Access Compliance Report

Public Rights-of-Way

Intersection ID: 43998	Main Street: GANDER_DR	Cross Street: SUMMERBERRY_CT	Location: NE
ADA ID: 0E171E373935	Ramp Type: BlendTrans1	Initial Pass/Fail: Fail	Overall Compliance: No
			Severity Score: 33.75

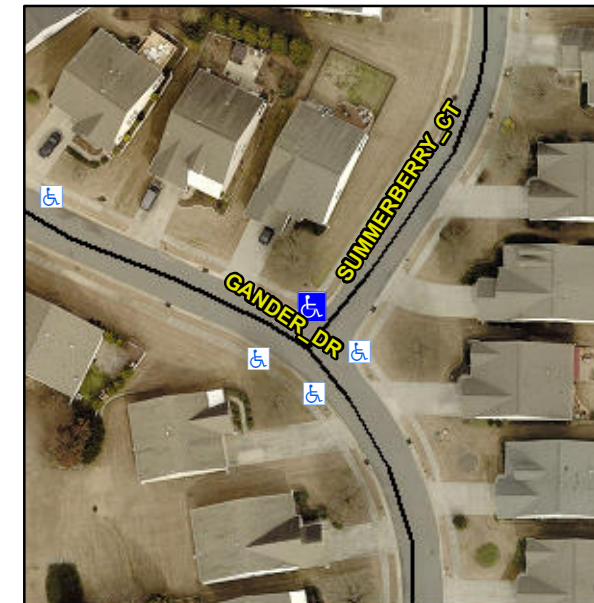
Not Found, R304.5.1, R304.5.3

Compliance	Description	Data	Compliance	Description	Data
N/A	Ramp Length (in)	46.0	Yes	BlendTrans Slope (%)	1.8
No	Ramp Width (in)	46.0	No	BlendTrans XSlope (%)	9.6
N/A	Flare Type LT	N/A	N/A	Flare Type RT	N/A
N/A	Flare Slope LT (%)	N/A	N/A	Flare Slope RT (%)	N/A
N/A	Flare Traversable LT?	N/A	N/A	Flare Traversable RT?	N/A
N/A	Landing Length (in)	N/A	N/A	DWS Provided?	N/A
N/A	Landing Width (in)	N/A	N/A	DWS Contrast?	N/A
N/A	Landing Slope (%)	N/A	N/A	DWS Length (in)	N/A
N/A	Landing X Slope (%)	N/A	N/A	DWS Full Width?	N/A
N/A	Landing Curb? (Y/N)	N/A	N/A	DWS Offset (in)	N/A
N/A	Shared Landing?	N/A			
N/A	Gutter Ponding?	N/A	N/A	Gutter Slope (%)	N/A
N/A	Gutter Lip Ht (in)	N/A	N/A	Gutter X Slope (%)	N/A
N/A	Painted X Walk1?	No	N/A	Painted X Walk2?	No
	X Walk 1 Direction	To SW		X Walk 2 Direction	To SE
	X Walk 1 Width (in)	N/A		X Walk 2 Width (in)	N/A
	X Walk 1 Slope (%)	7.1		X Walk 2 Slope (%)	1.1
	X Walk 1 X Slope (%)	2.9		X Walk 2 X Slope (%)	8.4

N/A	Ramp inside XWalk1?	N/A	N/A	Ramp inside XWalk2?	N/A
	Road Slope (%)	8.3		Clear Space?	N/A
	Road X Slope (%)	4.8	N/A	Clear Space to XWalk (in)	N/A
N/A	Any Obstructions?	N/A	N/A	Storm Grate/Utility Hazard?	N/A
	Obstruction Type			Storm Grate/Utility Type	
		N/A			N/A
			Yes	Surface Condition? (G/P)	Good
			No	Curb Slope (%)	14.4

Remove & Replace Curb Ramp With Two New Directional Ramps or Equivalent.
